INTERNAL MEMORANDUM

SUBJECT: P/26/0013 | Discharge of condition 7 (Lighting) of planning permission P/19/0073 for the provision of 36 camping pods and 5 chalets, erection of shower/toilet block and creation of play and picnic area. Construction of new parking area (150 spaces) with overflow carpark (46 spaces), together with a trail maintenance yard, new highway access routes, ground profile works, drainage, infrastructure and landscape works | Gethin Woodland Centre Abercanaid Merthyr Tydfil CF48 1YZ

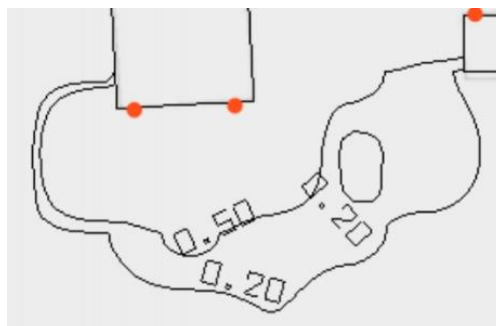
- o *The heat map style horizontal illuminance plans included within Document 1 are difficult to read particularly at the lower end of the lux range. Would it be possible to redraw the illuminance plans using simpler lux contour lines, see below for example:*

This could then be overlaid on the plan showing the positions of the trees with bat roost suitability and the bat flight lines to allow clarity and a better understanding/assessment of the potential impacts of the proposed lighting on the nocturnal wildlife at the site.

Document 4 is clearer in terms of the contours. An overlaid image has not been provided, however I have approximately overlaid the two images below, which shows that the positions of the trees with bat roost suitability and the bat flight lines are in darkness. This is acceptable.
